City of Fremont

RE: 6000 S CORPORATION, 6000 STEVENSON BLVD.

The document entitled "Work Plan, Sampling of Foundry Sands, 6000 Stevenson Boulevard, Fremont, California" prepared by Levine Fricke for 6000 S Corporation has been reviewed. The purpose of this phase of the investigation is to screen foundry sands for Soluble Threshold Limit Concentrations (STLCs) in order to determine appropriate off-site disposal options. Previous analytical data indicate elevated soluble lead concentrations in the sands above the STLC value.

AERIAL PHOTOGRAPH #AV-2640-6-61
5-15-85

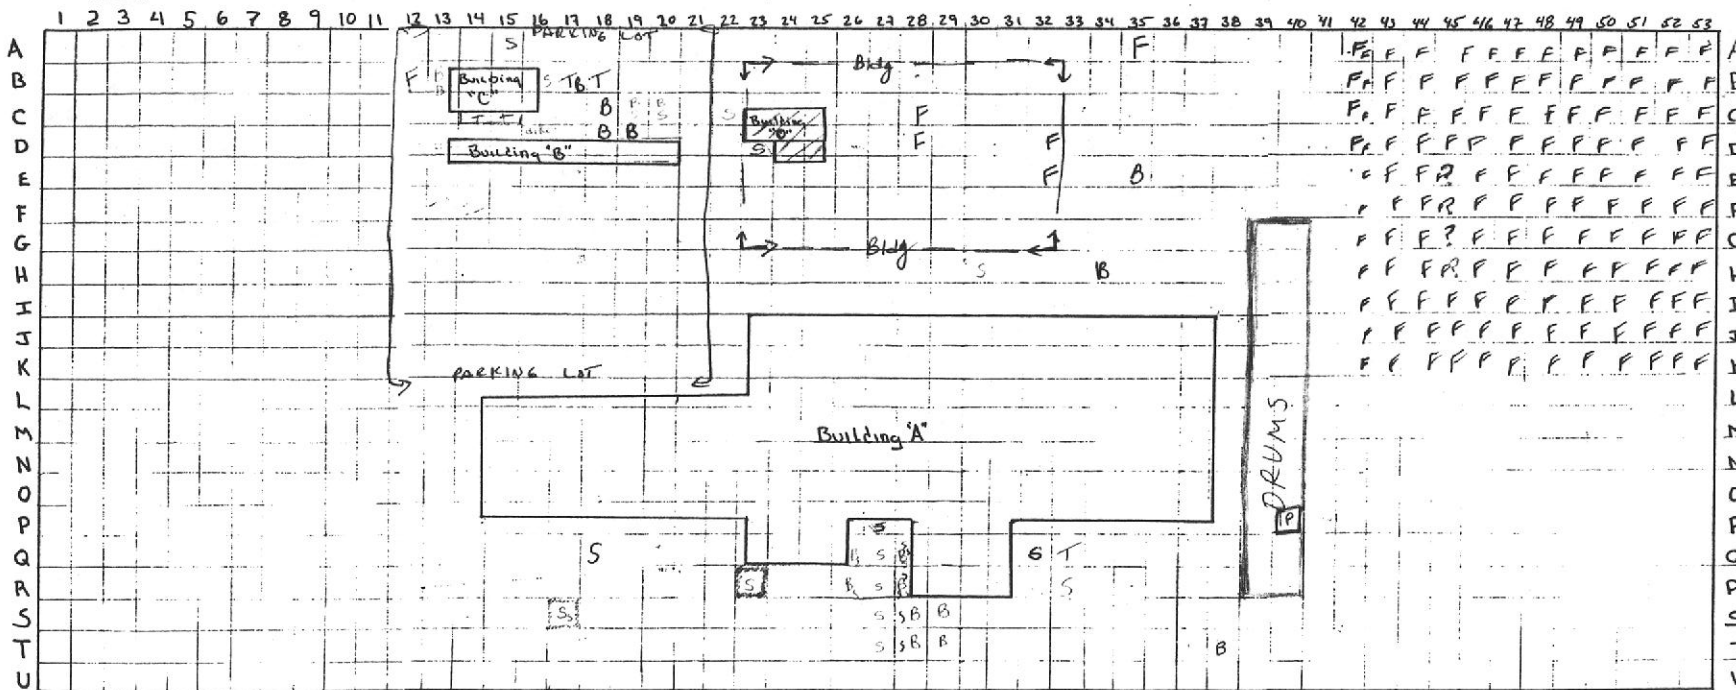
1. A stain with a circular pattern is visible at Q-32.
2. Stain evident at P, Q, R, S, T-28.
3. Fill "material" has been dumped at coordinates A, B, C, D-42 and at coordinates D, E-32.
4. Tanks have been removed from coordinates C-14,15 and, B-17,18.
5. Barrels are visible at coordinates B-17, C-18 and, D-18.
6. What appears to be a skeleton of a tank is visible on C-16.
7. Barrels are placed on soil at coordinate H-34 and, D-19.
